Product change New marking for SAW filters

141114SAW1e

Product / Process Change Notification

1. ID No.: M274		2. Date of announcement: November 14, 2014	
3. Product / product group: EPCOS SAW filters	Old ordering code: B39*B76*, B39*B77*, B39*B78*, B39*B79*, B39*B80*, B39*B83*, B39*B84*, B39*B85*, B39*B86*, B39*B87* except B39*B8753* and B39*B8755*, B39*B88*, B39*B90*, B39*B91*, B39*B93*, B39*B94*, B39*B95*, B39*B96*, B39*B97*, B39*B98*, B39*B99*	New ordering code: No change	Customer part number:

9. Identification of changed product (first date code / marking): New marking

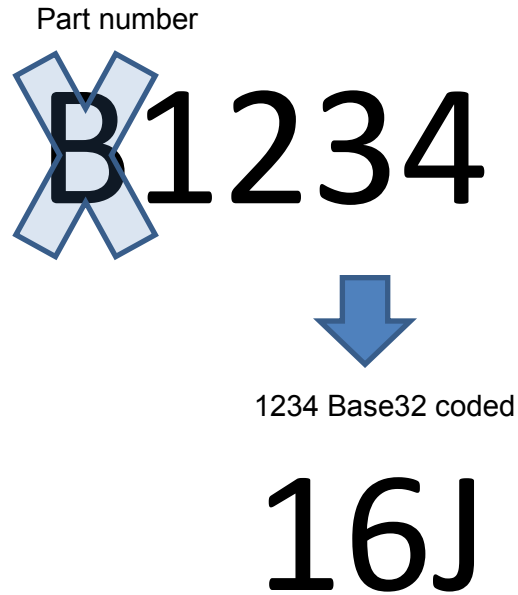
4. Description of change: For better traceability of EPCOS SAW filters, the marking on top of all products in CSSP technology will be replaced by coded information. More than one lot of a specific type can be produced in a single day. Accordingly, the date code used up to now is insufficient to identify an individual assembly lot. The new marking format includes a 3-digit BASE47 code in the bottom row encoding the last five digits of the complete 7-digit assembly lot number (without the A in front), which allow the product to be traced down to a single lot. In addition, a 3-digit BASE32 code in the top row encodes all digits of the device name (for details, see Annex 1 and 2).
